DWR PERRIS DAM EMERGENCY RELEASE FACILITY

Environmental Impact Report

Prepared for
Department of Water Resources

February 2018

FIGURE 4

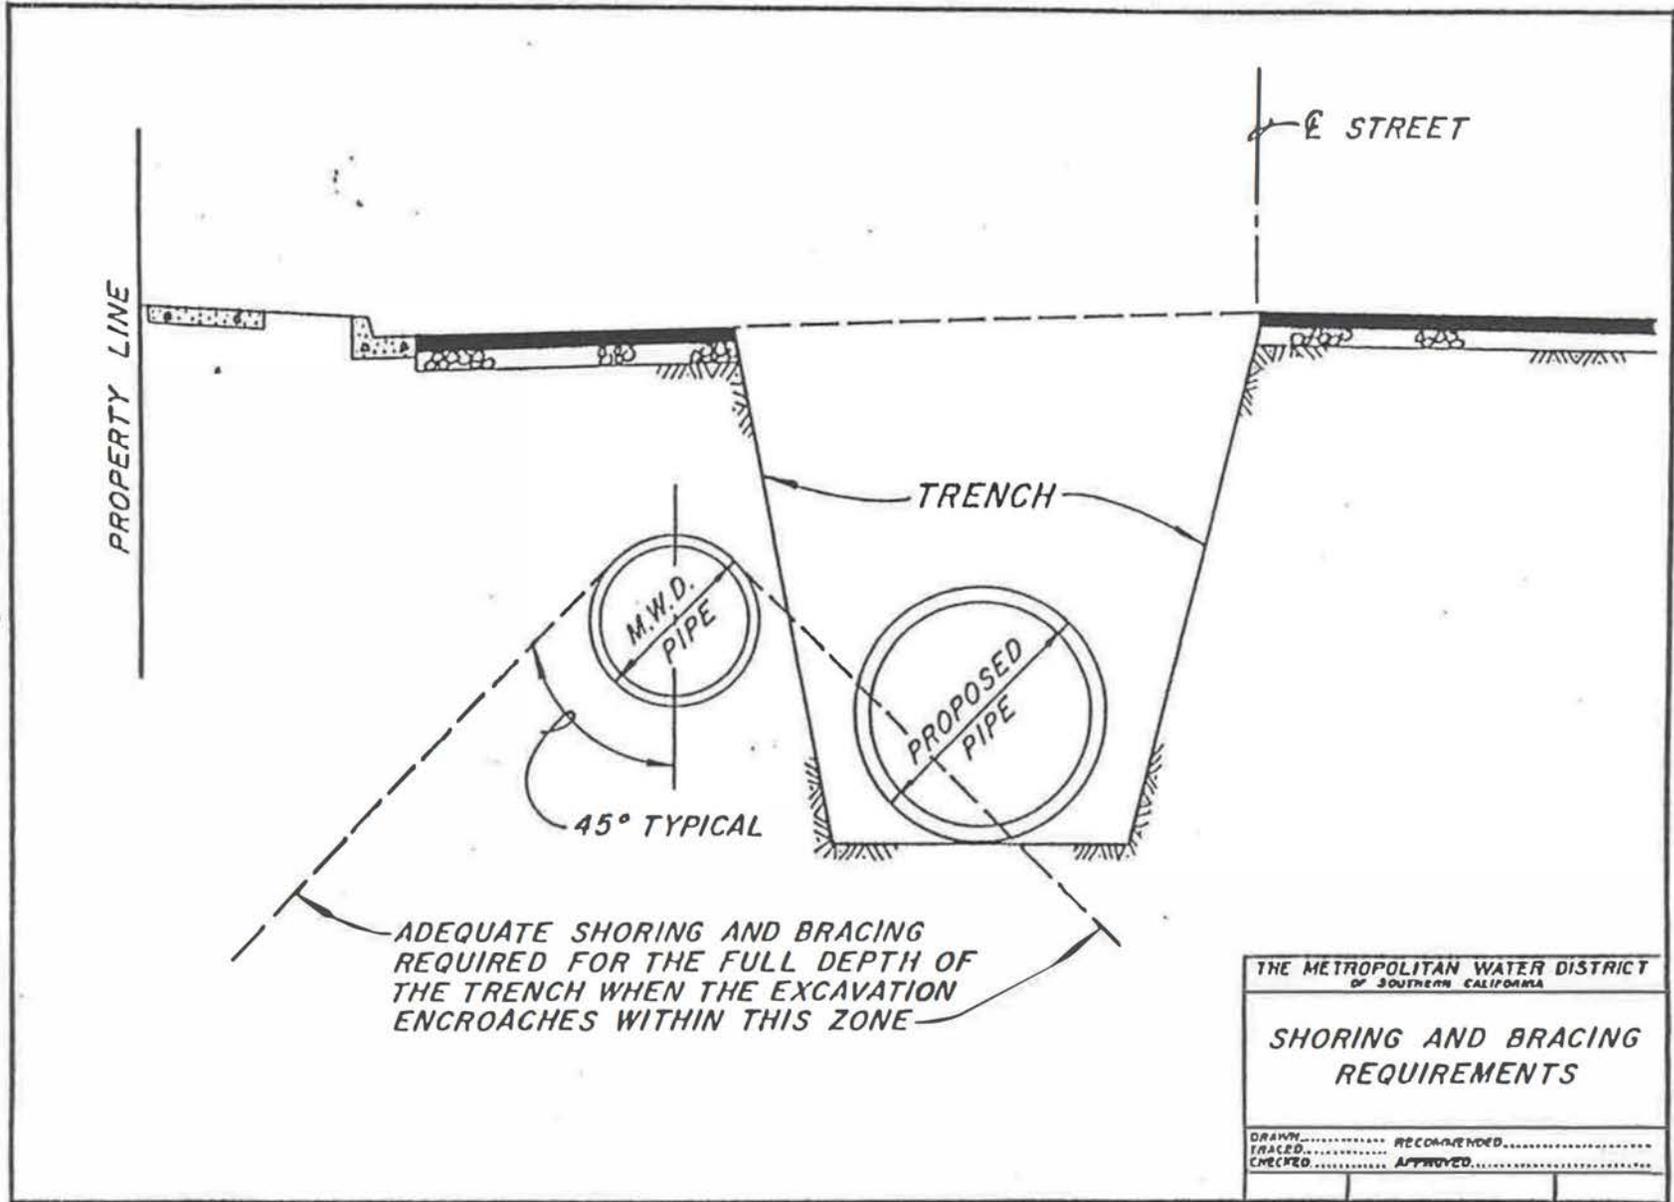
k. Adequate shoring and bracing is required for the full depth of the trench when the excavation encroaches within the zone shown on Figure 4.

Figure 2-6
Perris Dam
Cross Section

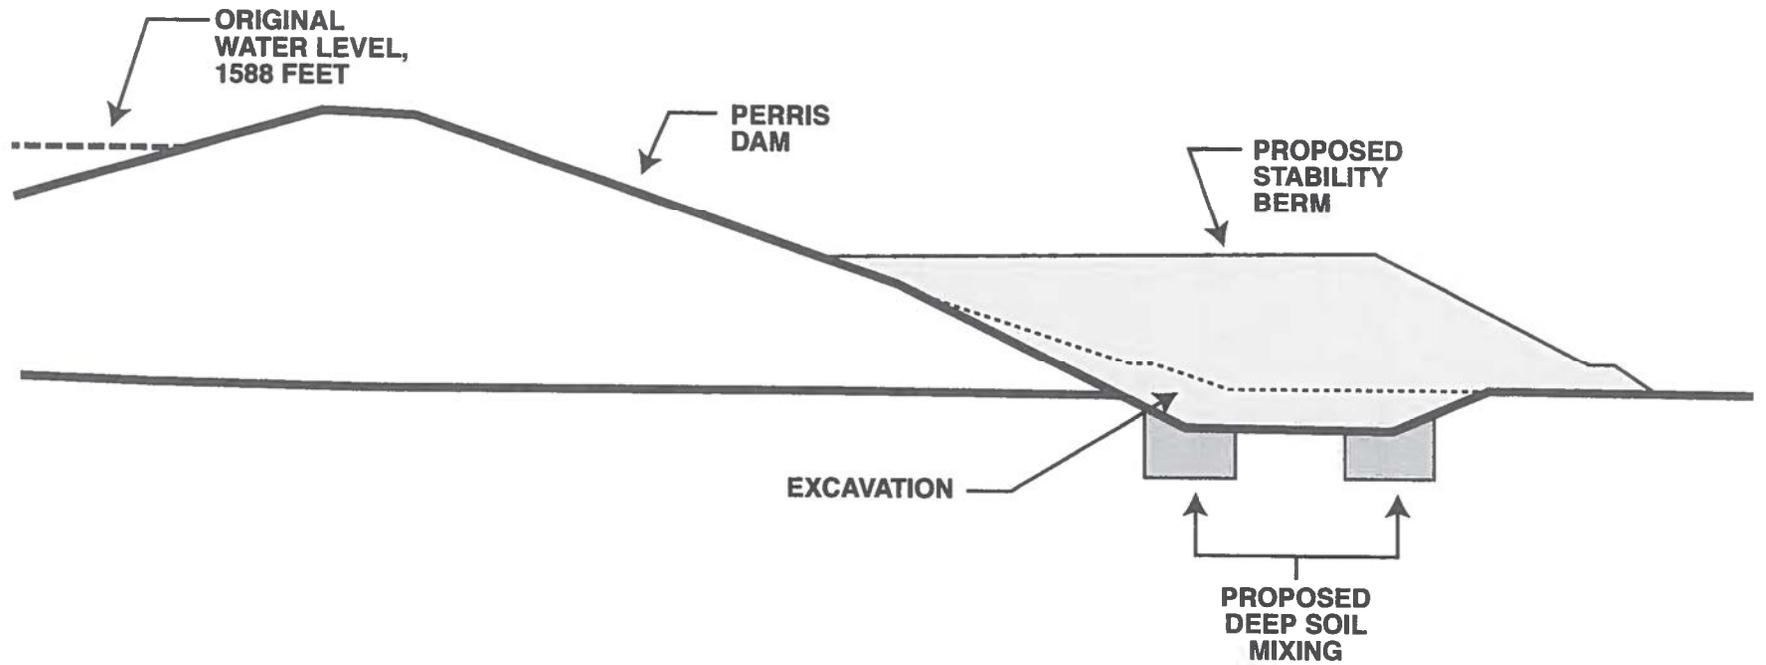
Approximately 700,000 cy of soil would be excavated from the shallow berm foundation at the toe of the dam. **Figure 2-6** provides a cross-section of the proposed excavation. Drain rock would be placed in the bottom lifts of the excavation to extend the existing drainage blanket to the new toe of the stability berm. The excavated material would be stockpiled on site and recompact as excavation backfill and as part of the stability berm. Approximately 800,000 tons of drain rock and 300,000 cy of soil would be backfilled into the excavation area.
